Job 72331508REP1	Truss A3	Truss Type Truss	Qty 2	Ply 1	Pro Bldrs / Clayton Craftsman - GL Job Reference (optional)
---------------------	-------------	---------------------	----------	----------	--

UFP Mid Atlantic LLC, 5631 S. NC 62, Burlington, NC, clm

Repair for a break in the web where indicated.

Job 72331508REP1	Truss A4	Truss Type Truss	Qty 1	Ply 1	Pro Bldrs / Clayton Craftsman - GL Job Reference (optional)
---------------------	-------------	---------------------	----------	----------	--

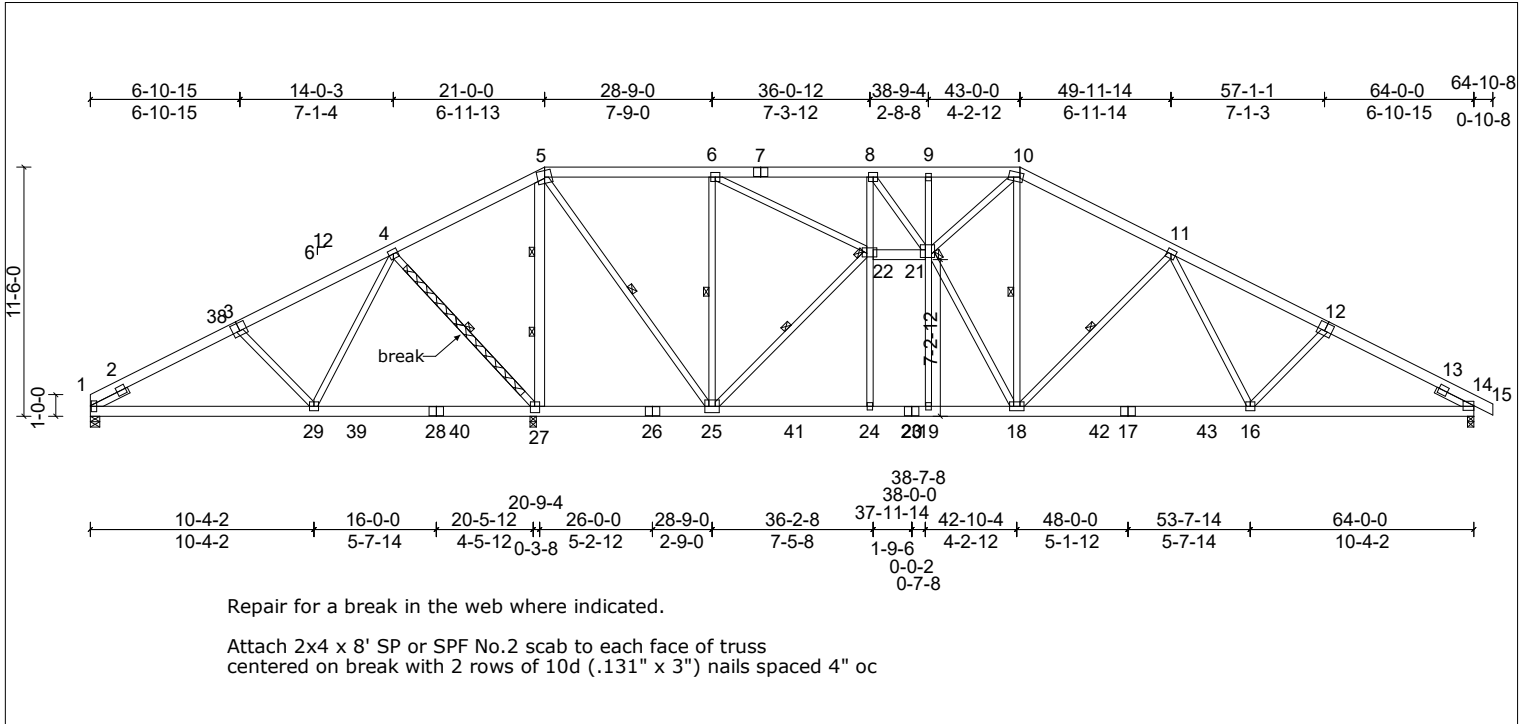
Repair for a break in the web where indicated.

Attach 2x4 x 8' SP or SPF No.2 scab to each face of truss centered on break with 2 rows of 10d (.131" x 3") nails spaced 4" oc

Job 72331508REP1	Truss A5L	Truss Type Truss	Qty 1	Ply 1	Pro Bldrs / Clayton Craftsman - GL Job Reference (optional)
---------------------	--------------	---------------------	----------	----------	--

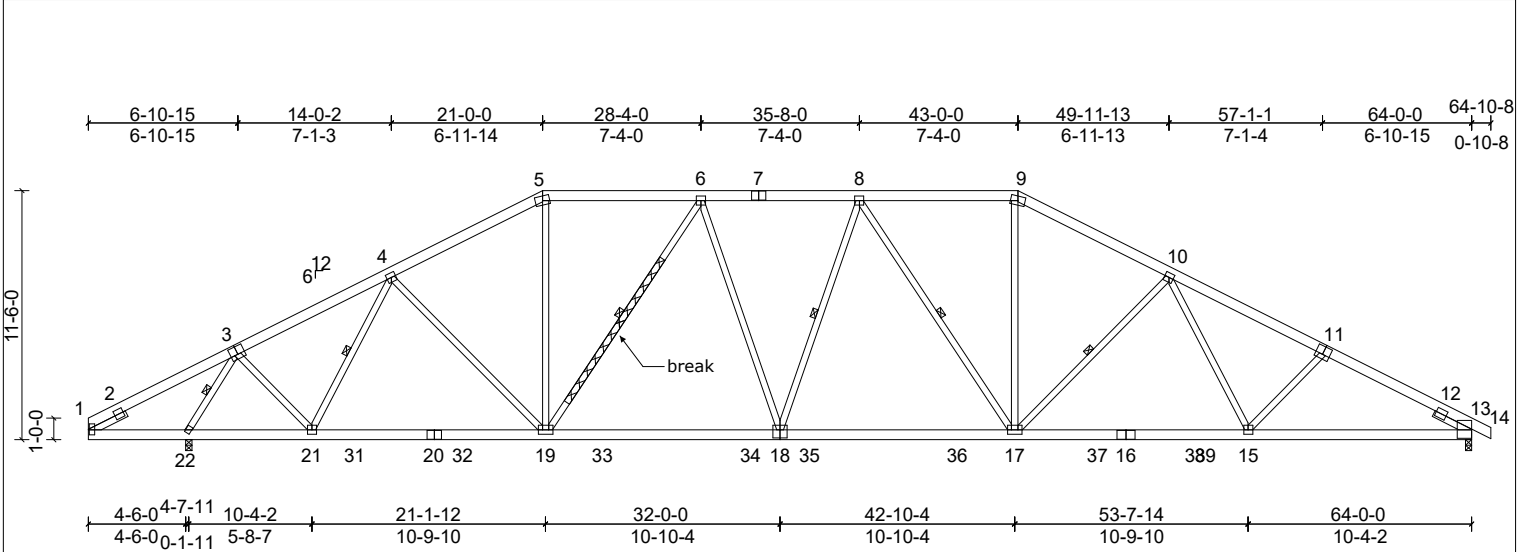
Repair for a break in the web where indicated.

Attach 2x4 x 8' SP or SPF No.2 scab to each face of truss centered on break with 2 rows of 10d (.131" x 3") nails spaced 4" oc

Job 72331508REP1	Truss A6	Truss Type Truss	Qty 1	Ply 1	Pro Bldrs / Clayton Craftsman - GL Job Reference (optional)
---------------------	-------------	---------------------	----------	----------	--

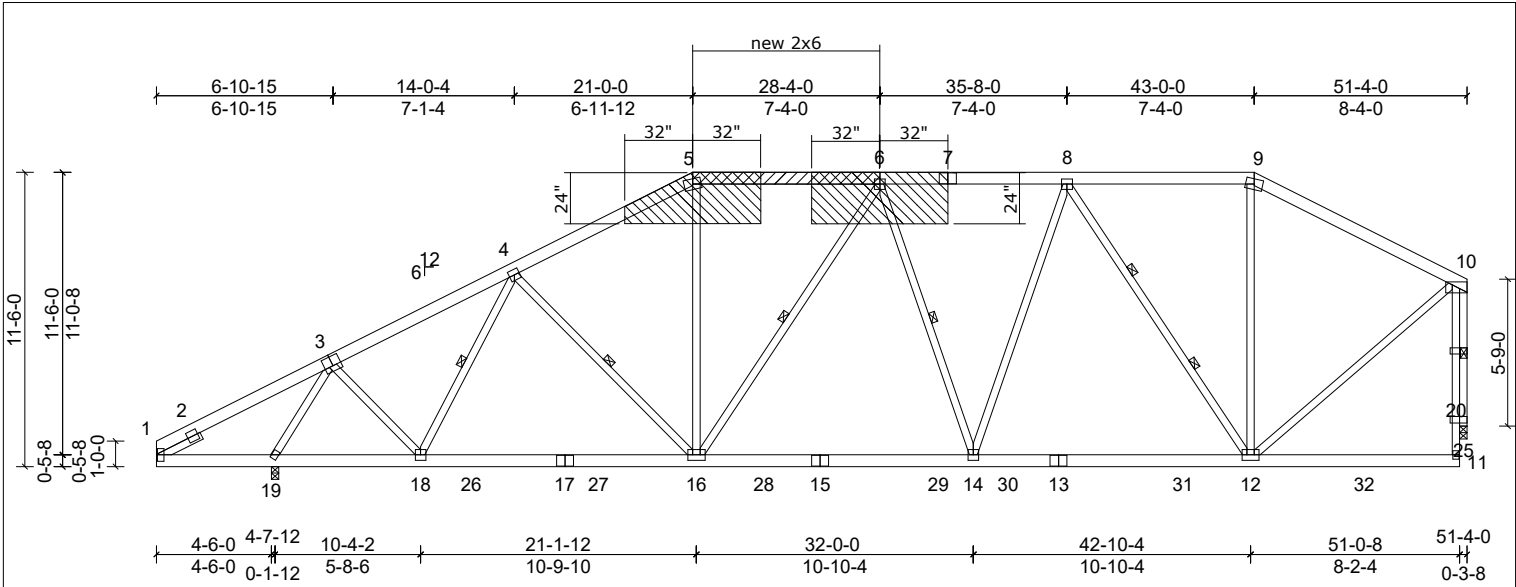
Repair to replace section of top chrd as shown

Cut and fit tight a new 2x6 SP or SPF No.2
Attach 1/2" Plywood or 7/16" OSB (APA Rated Sheathing Exposure 1) gusset
to both sides of truss as shown with two rows of 10d (.131" x 3") nails
spaced 4" oc in all members from each face, driven through both sheets of plywood.

Job 72331508REP1	Truss C1	Truss Type Truss	Qty 7	Ply 1	Pro Bldrs / Clayton Craftsman - GL Job Reference (optional)
---------------------	-------------	---------------------	----------	----------	--

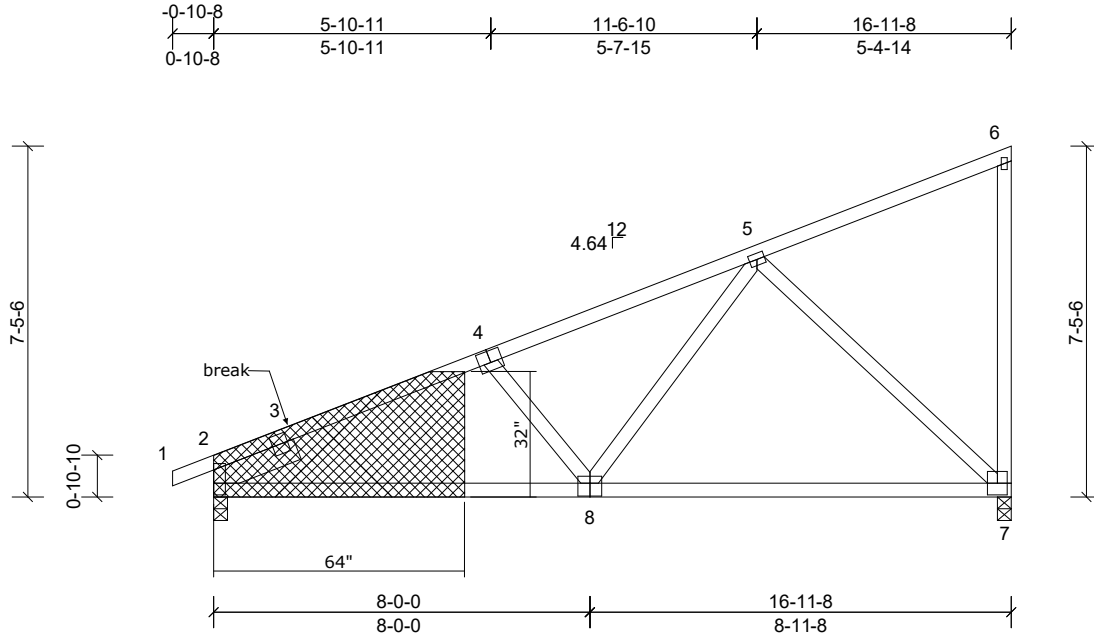
Repair for a break in the top chord where indicated

Attach 1/2" Plywood or 7/16" OSB (APA Rated Sheathing Exposure 1) gusset to both sides of truss as shown with two rows of 10d (.131" x 3") nails spaced 4" oc in all members from each face, driven through both sheets of plywood.
